Process Sheet

Customer :	CU-DAR001 Dart Helicopters Services	Drawing Name :	HELI UTILITY BASKET LH/RH 350/355
Job Number :	47941		
Estimate Number :	10208		
P.O. Number :		Part Number :	D350607043
This Issue :	13/05/2009	S.O. No. :	
Prsht Rev. :	NC	Drawing Number :	D350-607 REV F P7-9
First Issue :	/ /	Project Number :	N/A
Previous Run :	45949	Drawing Revision :	F
	Type :	Material :	
	LARGE FAB ASSY	Due Date :	22/05/2009
Written By :		Qty:	1
Checked & Approved By :	JLD 09.05.03	Um:	Each
Comment :	Est Rev:E as Per DSI9318 06-01-24 JLM Est Rev:F ECN1068 07-12-21 DD verified by:

DART SERVICE INSTRUCTION

TO AMEND INSTALLATION INSTRUCTIONS D350-607 REV. F

Figure 5- Basket Replacement Parts
(D350-607-043 Heli-Utility-Basket™)

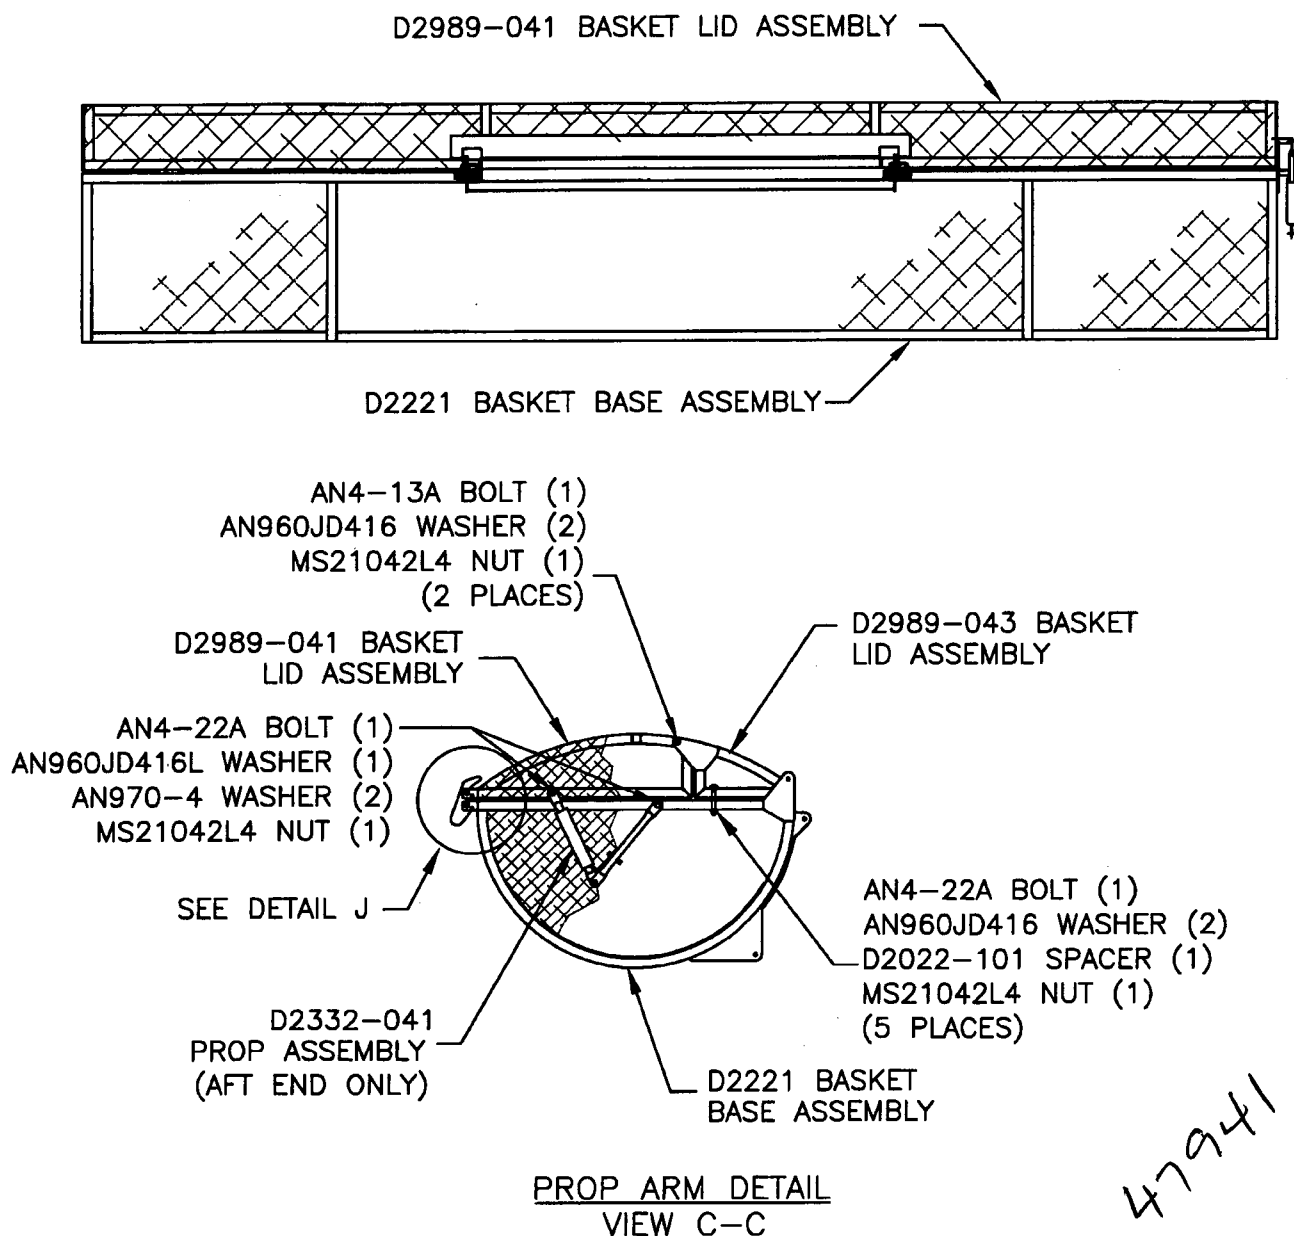
To reduce the possibility of damaging the finish, a **NAS1515H4** washer (2 places) has been added between the hinge plate and basket frame on the **D350-607-043/-047 Heli-Utility-Basket**.

The corrected bolt stackup from Figure 5 of installation instructions D350-607 Rev. F is given below:

AN4-13A BOLT (1)
AN960JD416 WASHER (1)
HINGE PLATE (REF)
NAS1515H4 WASHER (1)
BASKET FRAME (REF)
AN960JD416 WASHER (1)
MS21042L4 NUT (1)
(2 PLACES)
